SUBJECT: Rinker Materials Corporation
Request for Addition Information (SW-1117/F #10118)
Solid Waste Management Facility Permit Application
Waste Tire Processing Facility
Facility ID No. 0146251

This letter is in response to your November 24, 2003 letter requesting addition information (RAI) concerning the above referenced application. The responses are in the same order as presented on page two of the RAI.

PLANT LAYOUT

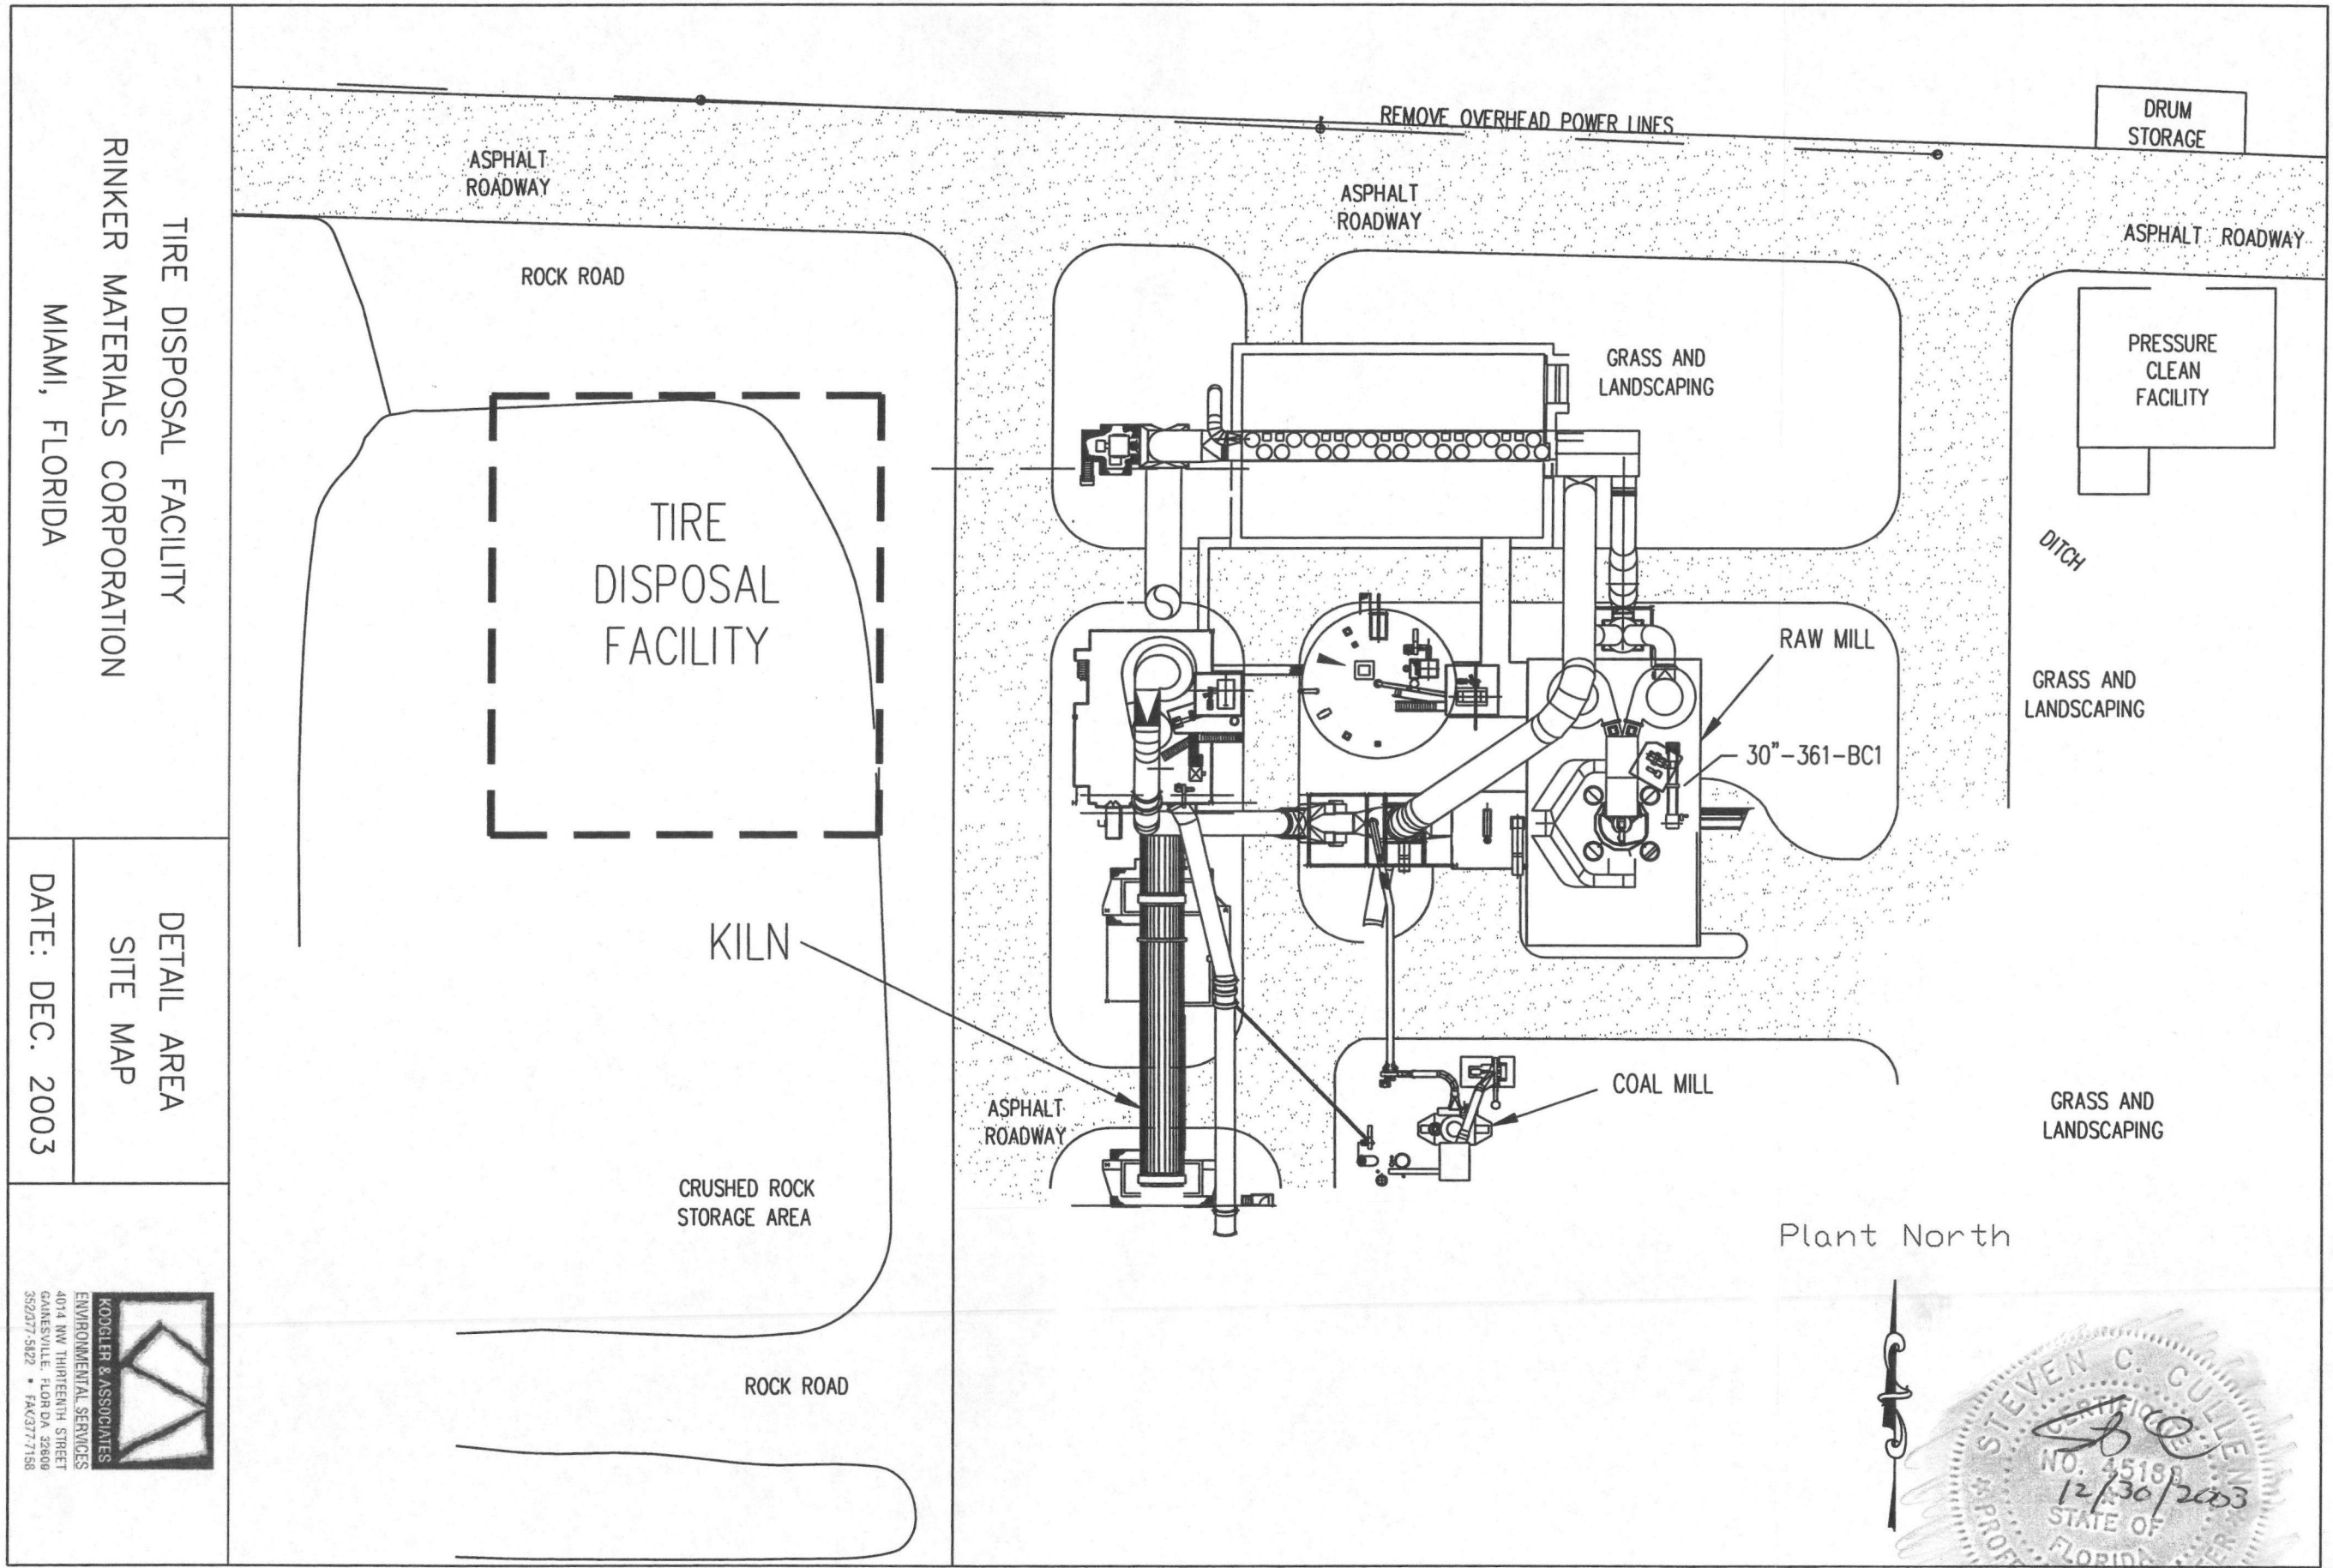
1. a) The plot plans (Attachment A.2) of the permit application is not legible.

Carlos Hernandez (DERM) stated that the department would accept a site map (boundary survey) along with a detail of the area in question if the engineer of record would sign and seal the drawings. Please refer to the "Plant Layout" and "Detail Area Site Map" drawings included in the attachments.
